Access Compliance Report

Public Rights-of-Way

(Curb Ramps)

Intersection ID: 24040	Main Street: FOX_CHAPEL_LN	Cross Street: HAWK_CREST_CT	Location: S
ADA ID: 827E8874D7DE	Ramp Type: BlendTrans1	Initial Pass/Fail: Pass	Overall Compliance: No
Severity Score: 7.5			
Codes/Mitigation Info/Possible Solution		Field Measurements/Component Compliance

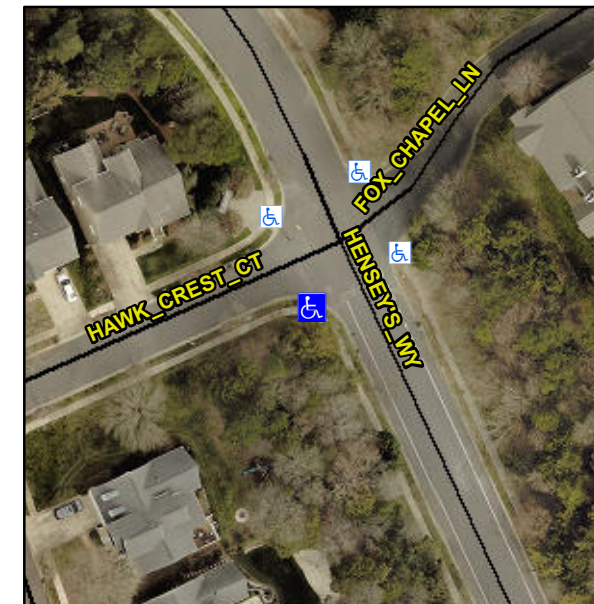
Remove & Replace Curb Ramp With Two New Directional Ramps or Equivalent. Remove & Replace Gutter.

Not Found, R305.1.4, R305.2, R304.5.4
